Grimes City Council Agenda

Topic: Grimes City Council February 23, 2021

- A. Public Hearing and First Reading of Ordinance 747 Rezoning of Property at SE 19th and James Street
- B. Public Hearing and First Reading of Ordinance 748 2018 Building and Fire Code Adoption
- C. Approval of Site Plan – 1861 SE Princeton Drive

NOT TO SCALE

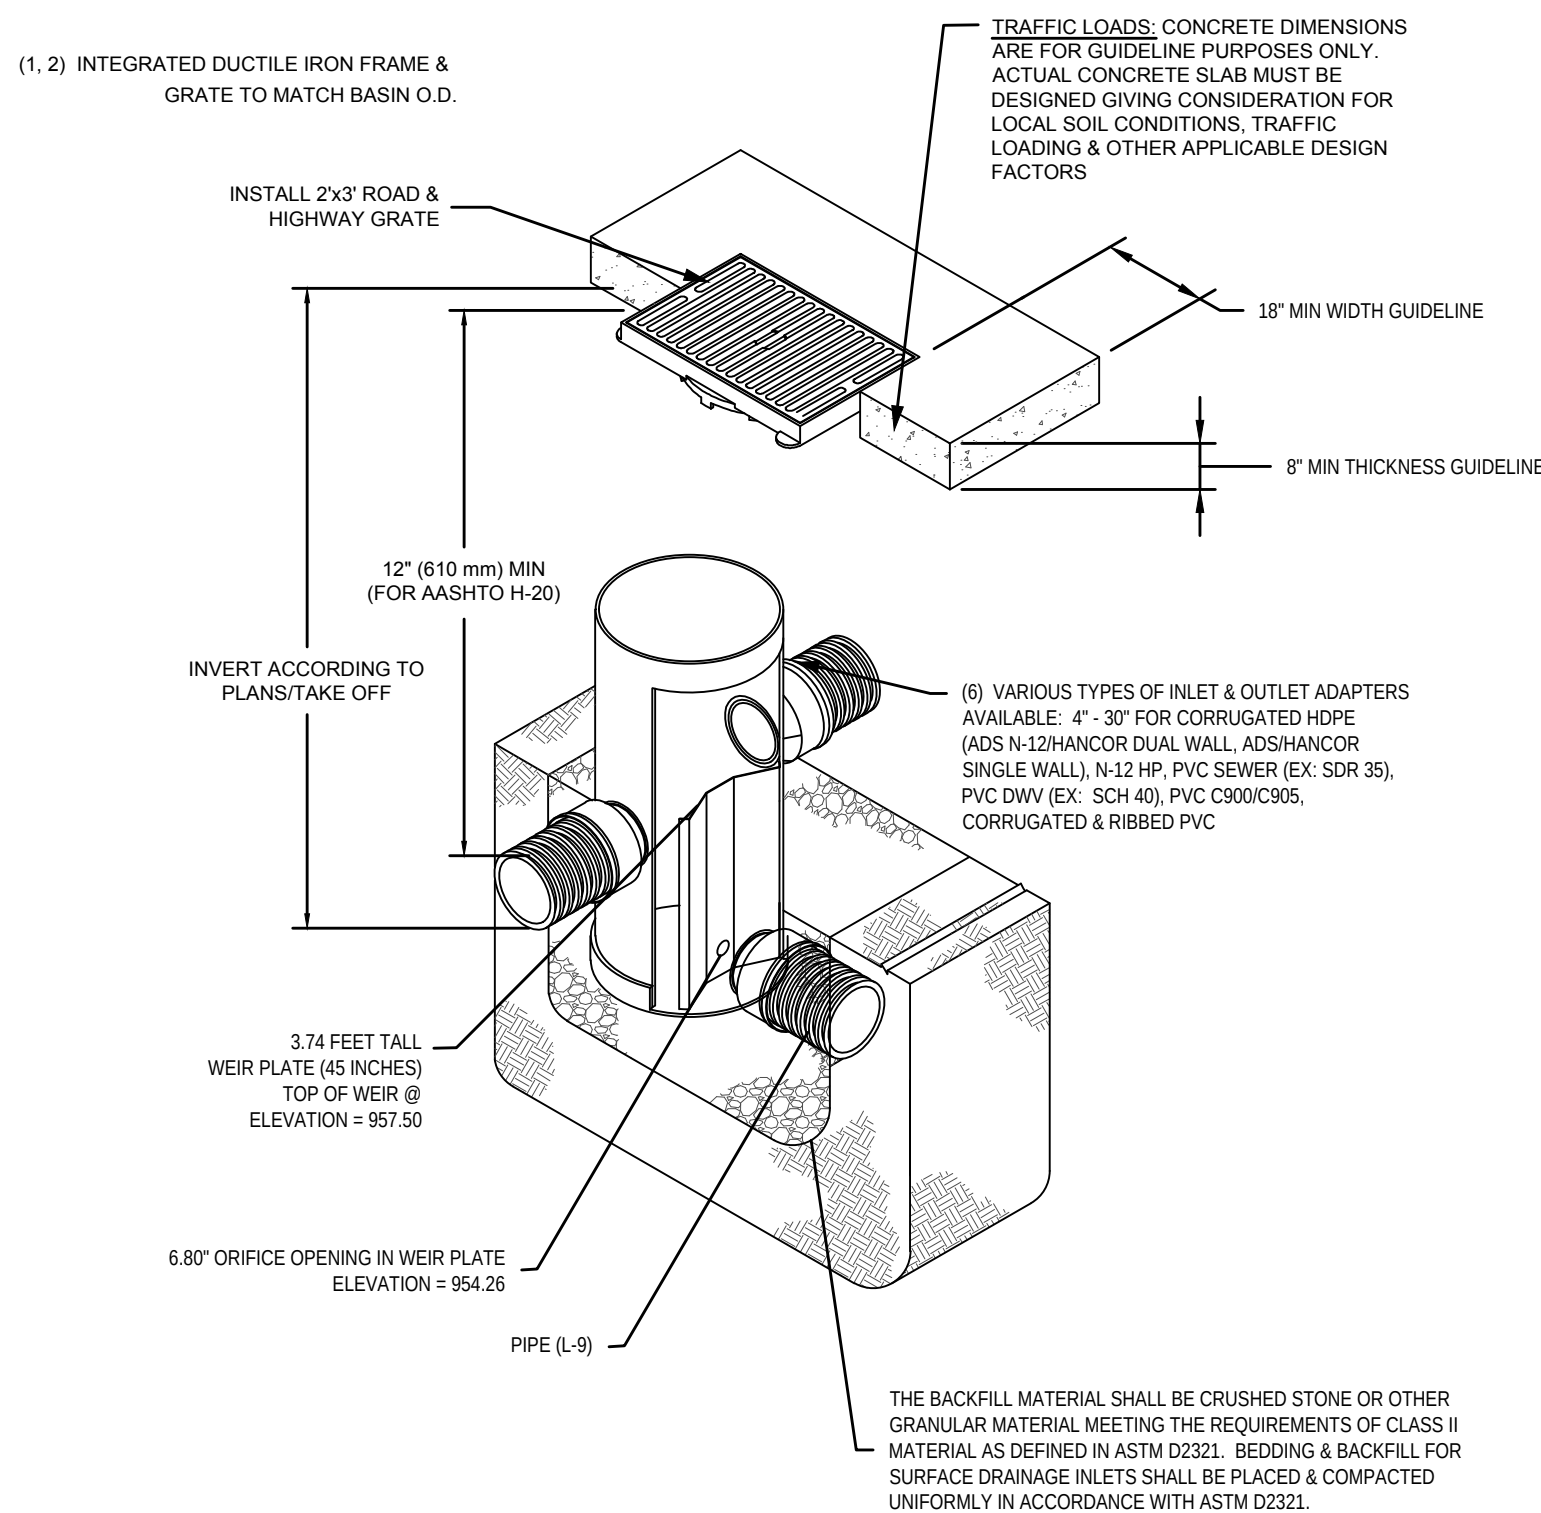
- ~~12. Sheet C5.2: Rename as sheet C5.2.~~

~~13. Sheet C5.2: Details shown are just typical. Please provide specific details for this design. Size of chambers, isolator row, what is the perforated line on the west side of the chambers (if this is an underdrain, what size is it, and is it below the chamber systems at ele. 954.51, and is it below the outlet pipe ele. 954.36), depth of rock above and below chambers, are there any inspection ports.....~~
